MANNIS ADDITION TO SEDGWICK COUNTY, KANSAS

RE: SUB 2001-62 -- One-Step Final Plat of Mannis Addition

RE: SUB 2001-62 -- One-Step Final Plat of Mannis Addition

CASE NUMBER: SUB 2001-62 -- MANNIS ADDITION

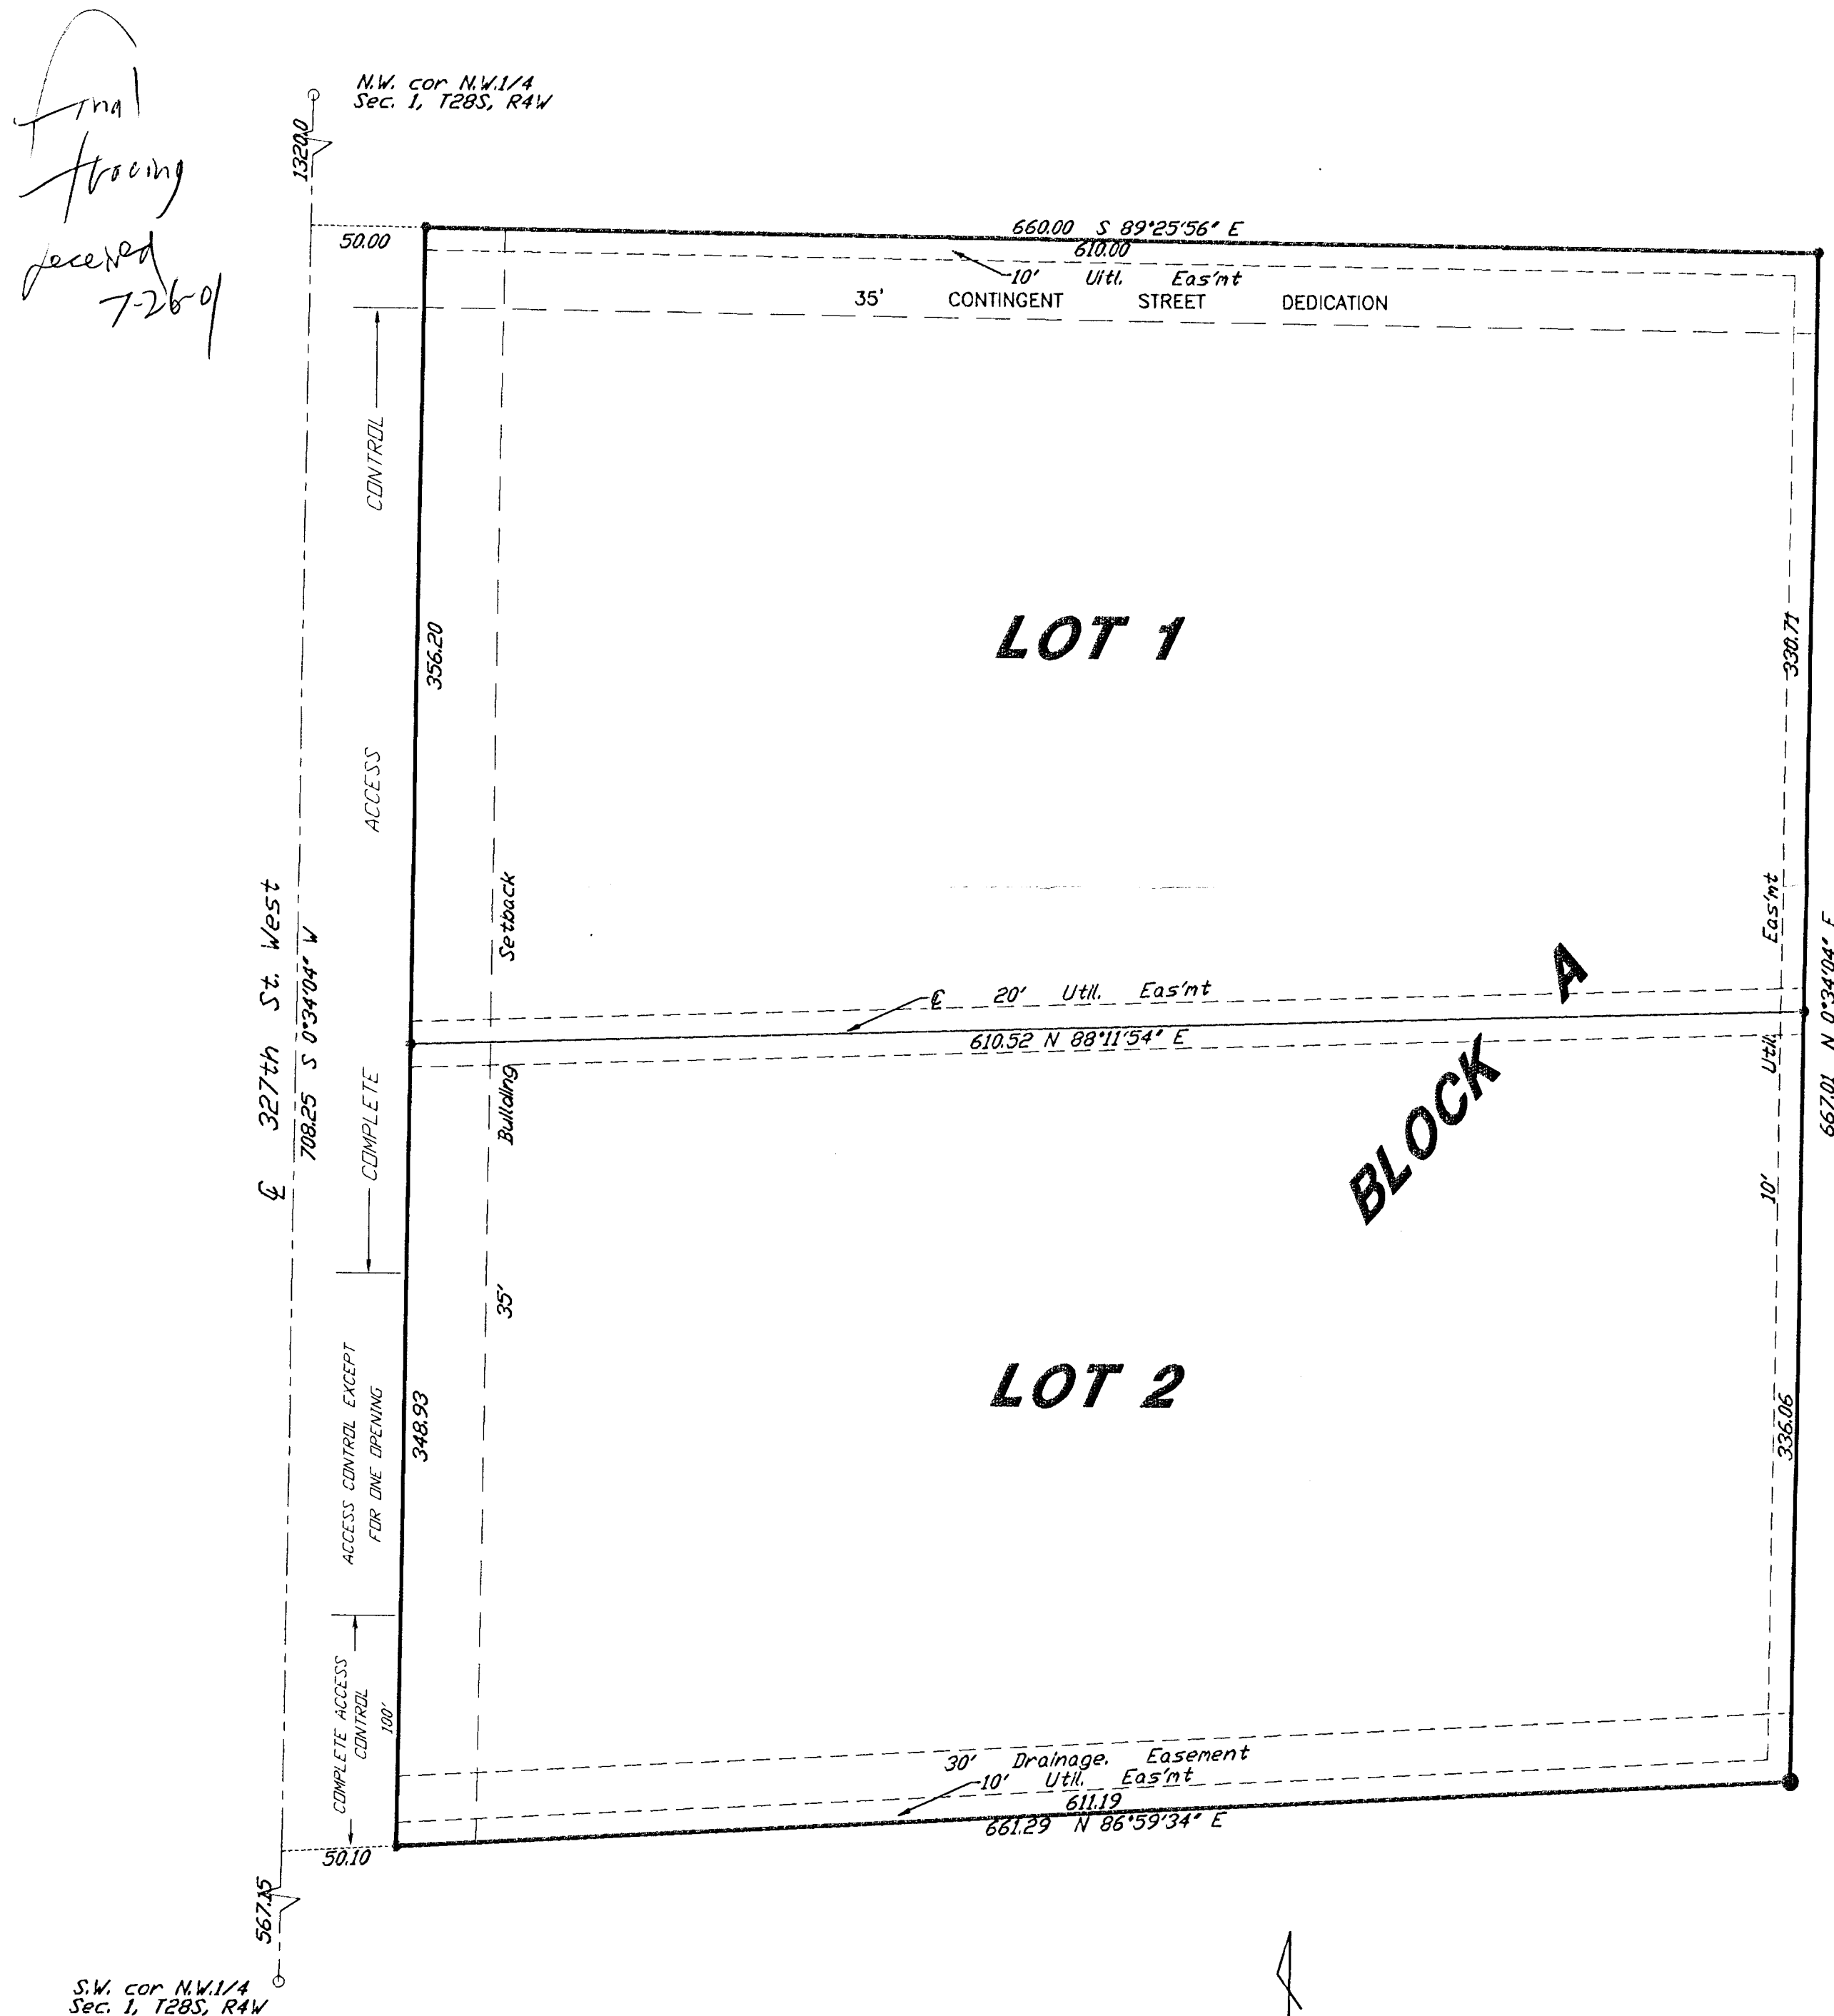
- C. County Engineering needs to comment on the status of the applicant's drainage plan. There appears to be terraces and drainage structures on this site. The Applicant shall coordinate the removal or modification of terraces with NRCS. A Master Drainage Plan is needed. The Drainage Plan shall reflect disposition of terraces. Drainage Reserves may be required along 327th St. West pending review of Master Drainage Plan.

- D. Based upon the legal description shown on the plat, the site involves the land extending to the section line and consequently the 50-ft strip along the west line of the plat would be a dedication of street right-of-way for 327th St. West. Both the face of the plat and the platlor's text shall denote and reference such dedication.

- E. County Engineering needs to comment on the access controls and the need for a joint access opening. The plat proposes one access opening per lot. County Engineering has approved one opening per lot. The opening for Lot 1 shall be in alignment with the contingent street right-of-way. The opening for Lot 2 shall be located along the northern portion of the lot.

- F. The platlor's text should include the reference to 327th St. West in regards to access controls.
- G. The face of the plat should designate a block number or letter, as is referenced in the platlor's text.

- H. On the final plat, the MAPC signature block needs to reference "J.D. Michaelis, Acting Chair".
- I. The signature line for the County Commissioners Chair needs to reference "Carolyn McGinn".

- J. The Applicant shall plat a 35-ft contingent street right-of-way along the north property line of Lot 1 for future connection to adjoining properties. The contingent street dedication shall be referenced in the platlor's text.

- K. The Applicant is advised that if platted, the building setbacks must be 35 feet to conform with the Zoning setback standard for County section line roads.

- M. The platlor's text shall include language that a drainage plan has been developed for the plat and that all drainage easements, rights-of-way, or reserves shall remain at established grades or as modified with the approval of the applicable City or County Engineer, and unobstructed to allow for the conveyance of stormwater.

- O. The applicant's engineer is advised that the Register of Deeds is requiring the name(s) of the notary public, who acknowledges the signatures on this plat, to be printed beneath the notary's signature.
